REQUEST FOR PROPOSAL (RFP)
NEW YORK AVENUE MEN'S SHELTER RENOVATIONS

Solicitation Number: DCAM-19-AE-0006

Addendum No. 3

Issued: July 10, 2019

BASEMENT FLOOR PLAN

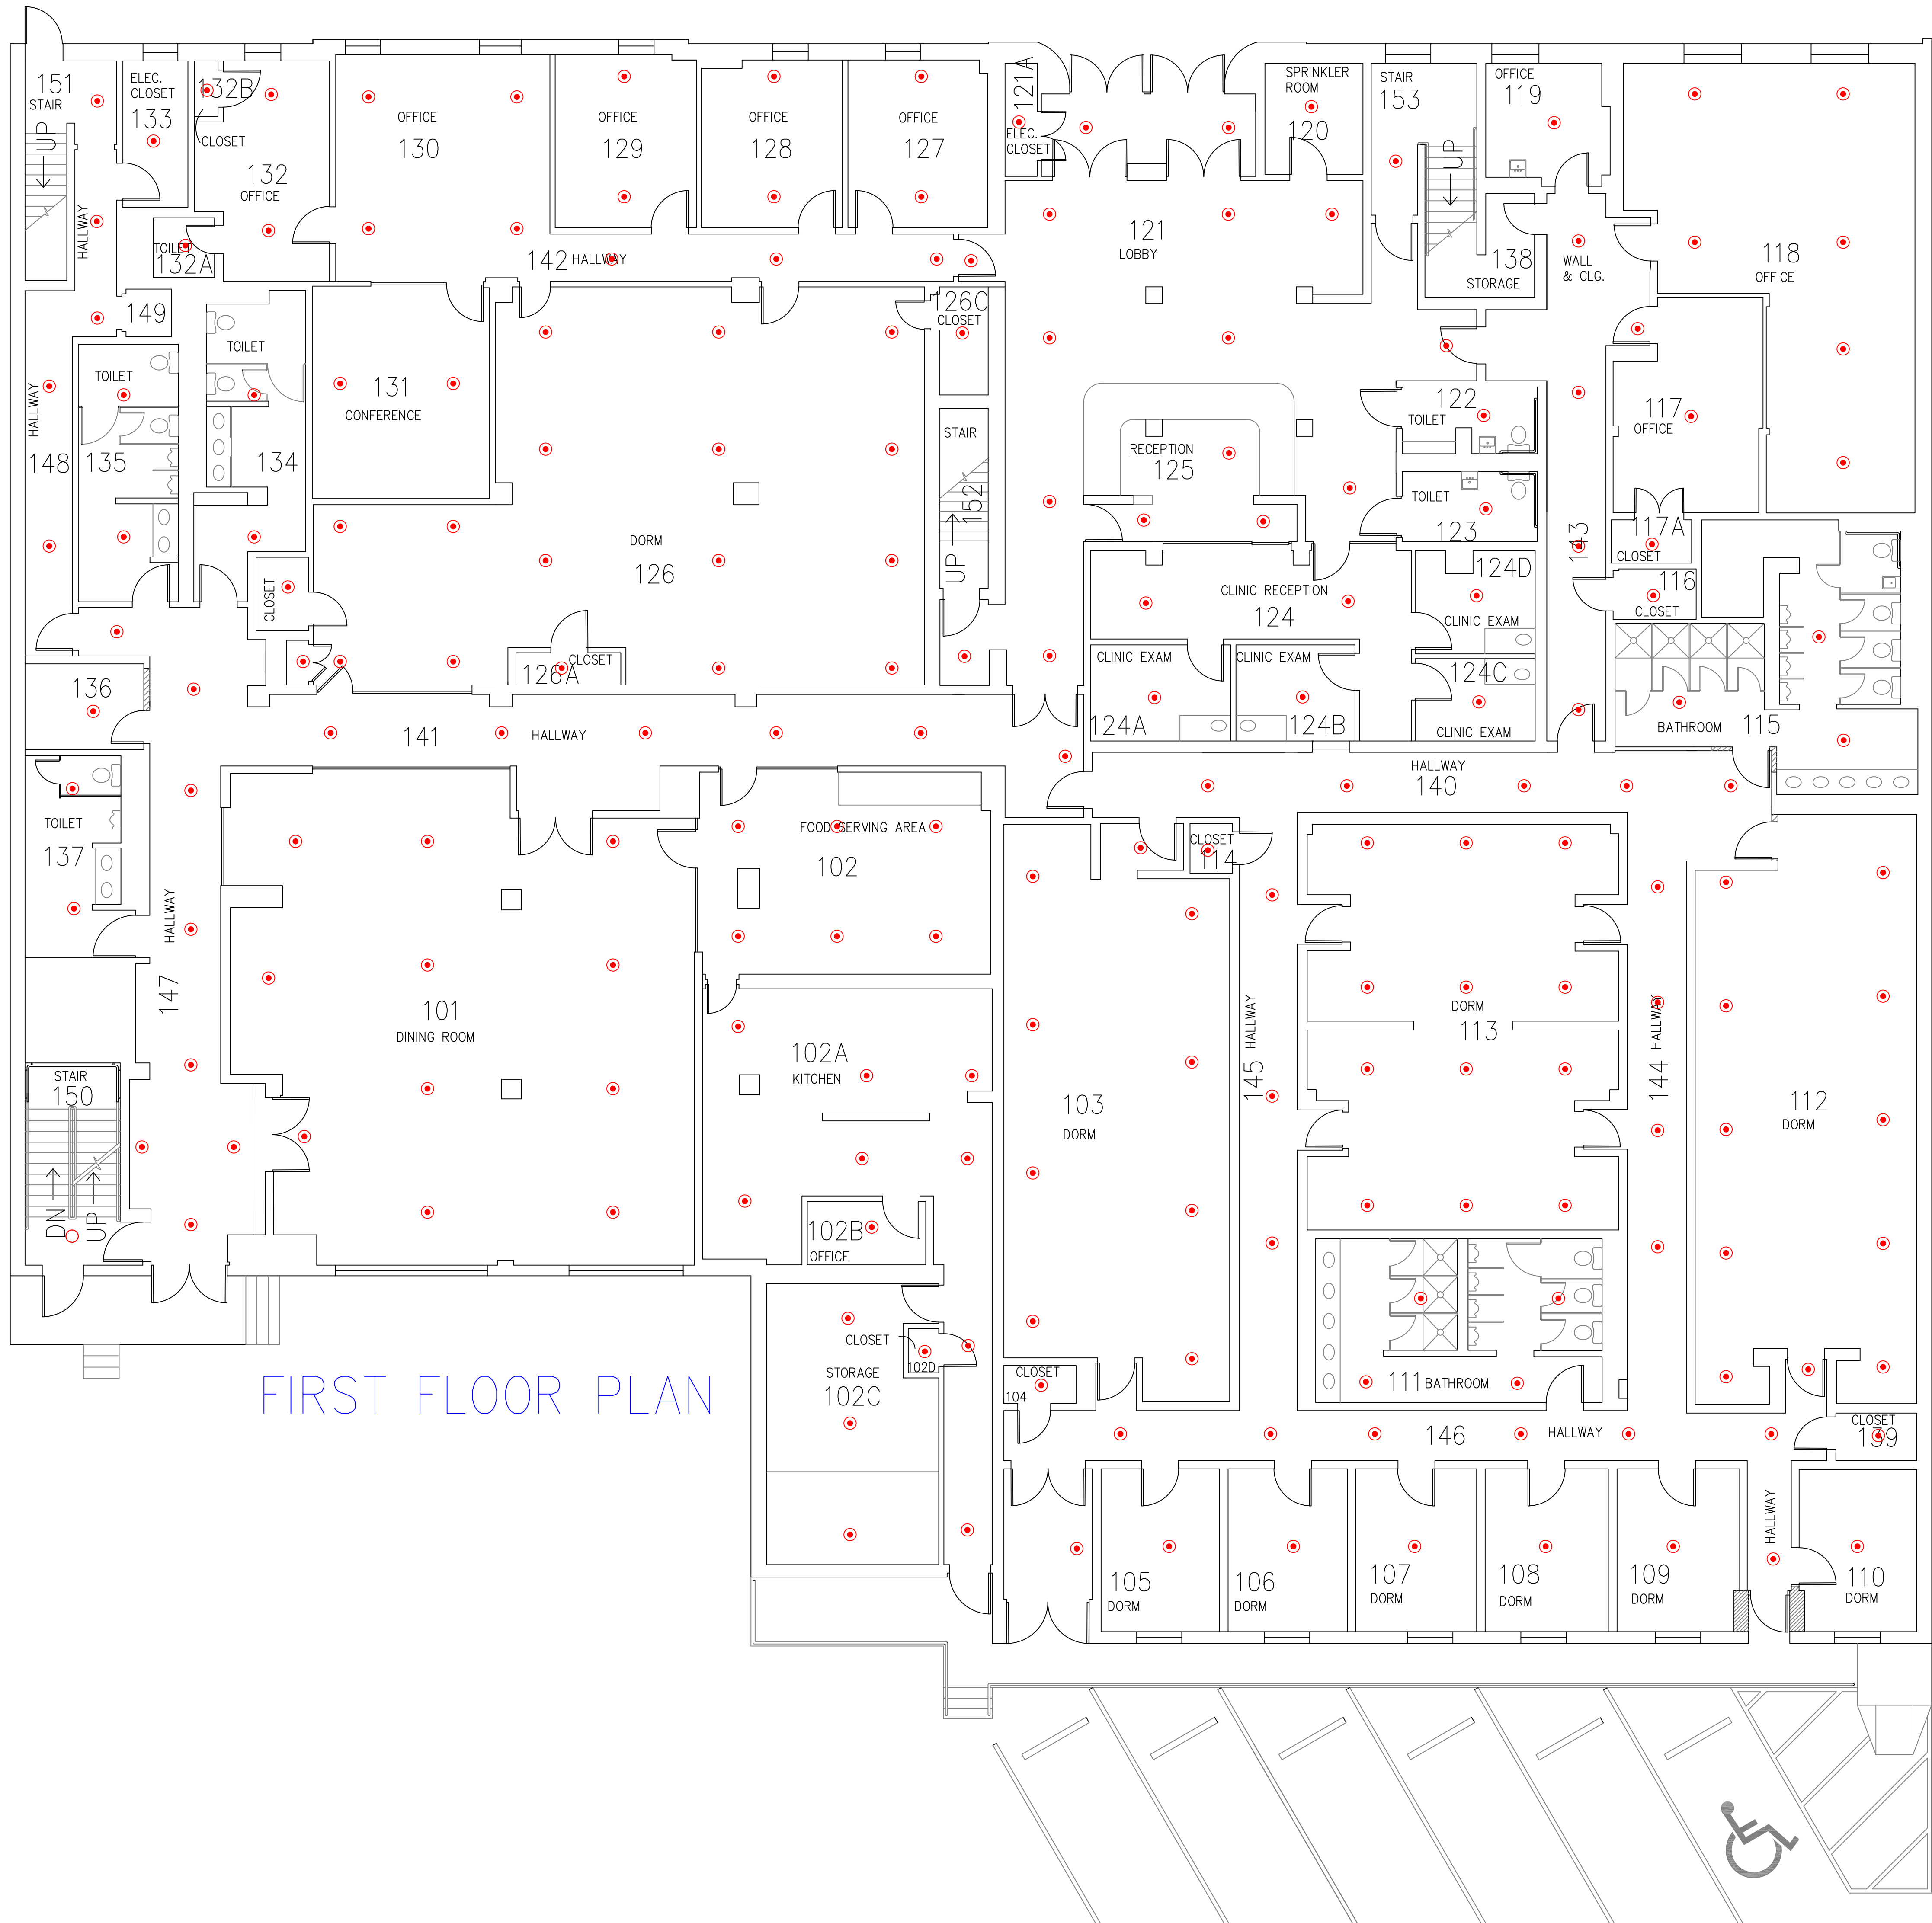
ONE-FOR-ONE REPLACEMENT OF EXISTING SPRINKLER HEADS

FIRST FLOOR PLAN

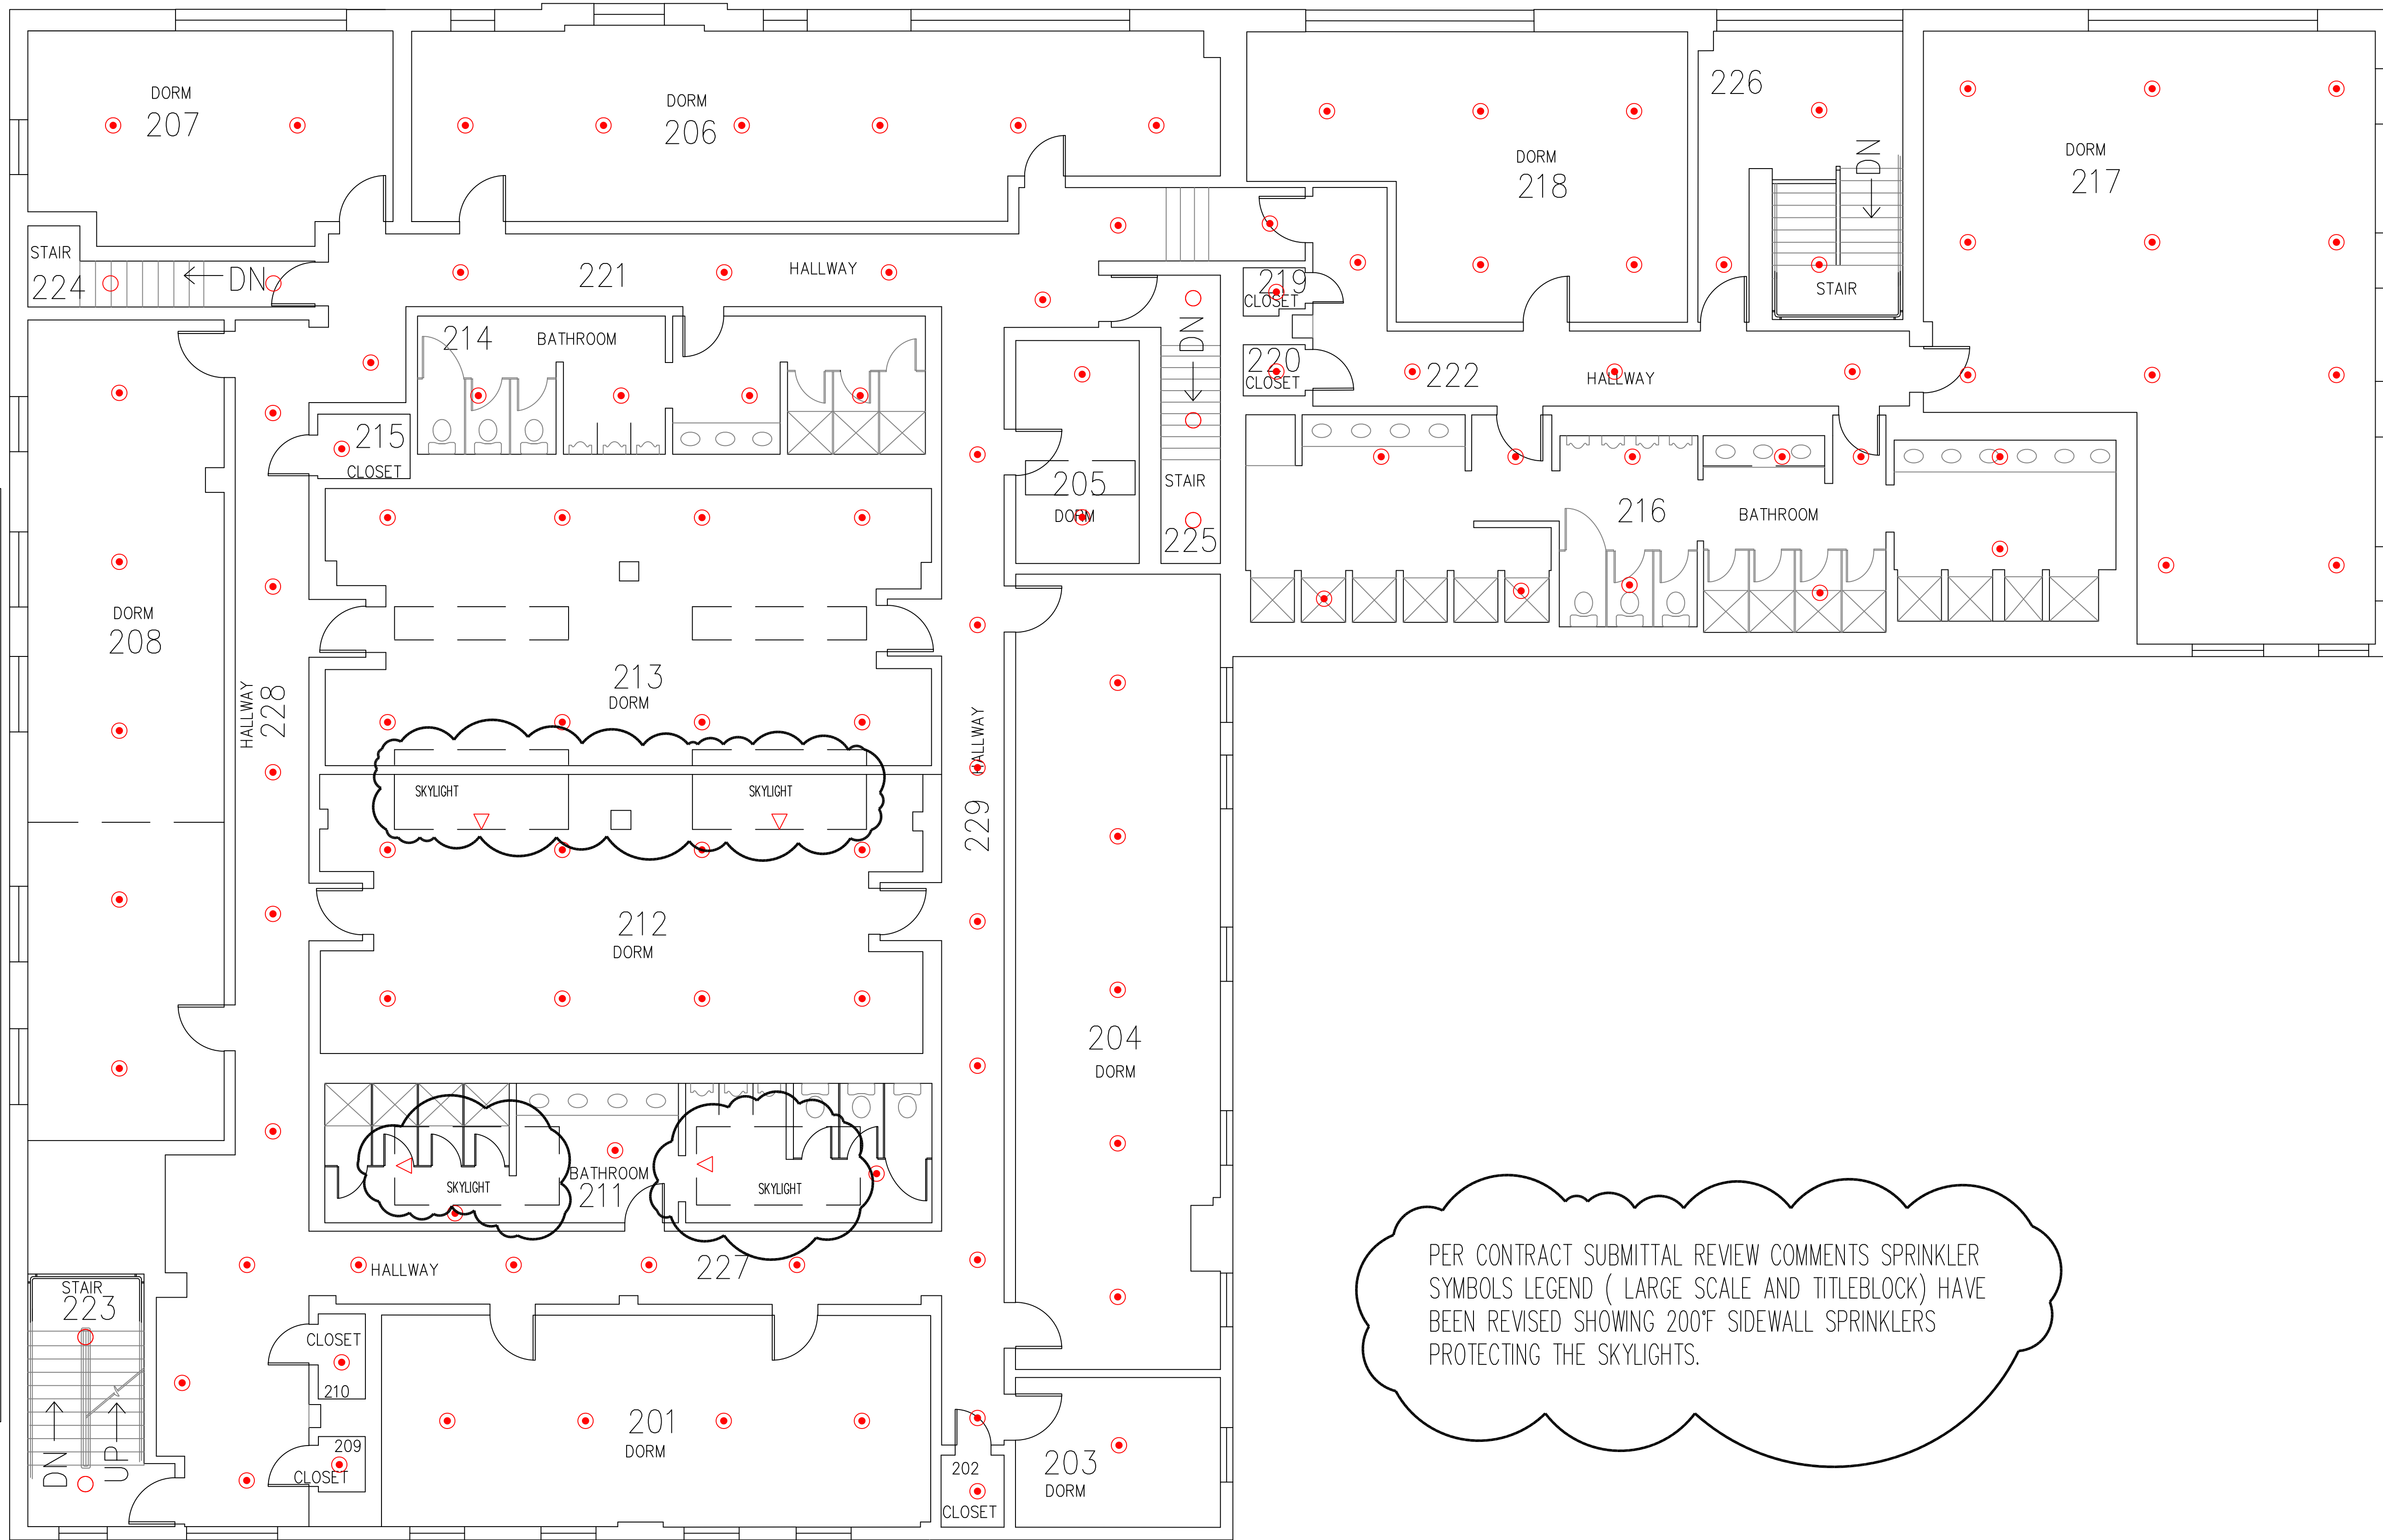
PER CONTRACT SUBMITTAL REVIEW COMMENTS SPRINKLER SYMBOLS LEGEND (LARGE SCALE AND TITLEBLOCK) HAVE BEEN REVISED SHOWING 200°F SIDEWALL SPRINKLERS PROTECTING THE SKYLIGHTS.
